Appl. No. 10/591,879  
Amdt. Dated November 1, 2007  
Reply to Office Action of August 30, 2007

### DRAWING AMENDMENTS

FIG 3A

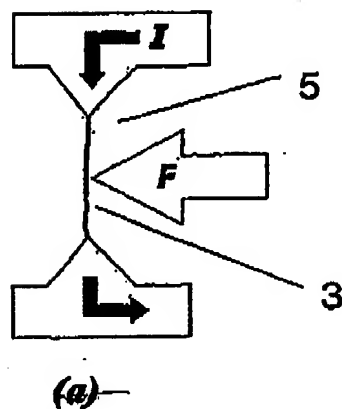
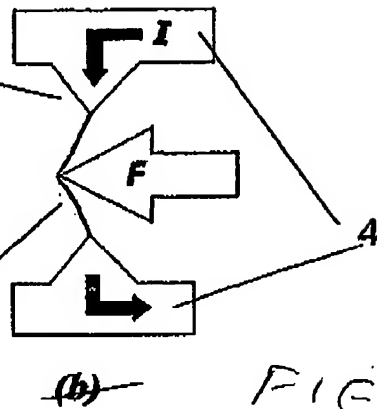
The attached sheet of drawings includes changes to Fig. 3A, Fig. 3B, Fig. 4A, and Fig. 4B. This sheet, which includes Figs. 3A, 3B, 4A, 4B, and 5, replaces the original sheet including Figs. 3A, 3B, 4A, 4B, and 5. In Fig. 4A, the label "Prior Art" has been added. The labels Fig. 3A, Fig. 3B, Fig. 4A, and Fig. 4B are now shown in the manner required by the regulations.

Additionally, the labels Fig. 3A, Fig. 3B, Fig. 4A, and Fig. 4B are now shown in the manner required by the regulations

FIG. 4A

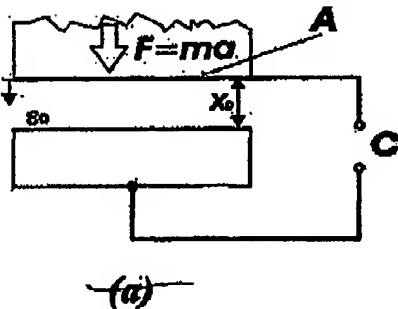
The Examiner required Fig. 4A to be designated as "Prior Art" and that change has been made.

Please approve the drawing changes that are marked in red on the accompanying "Annotated Sheet Showing Changes" of Fig. 4a. A formal "Replacement Sheet" of amended Fig. 4a is also enclosed.
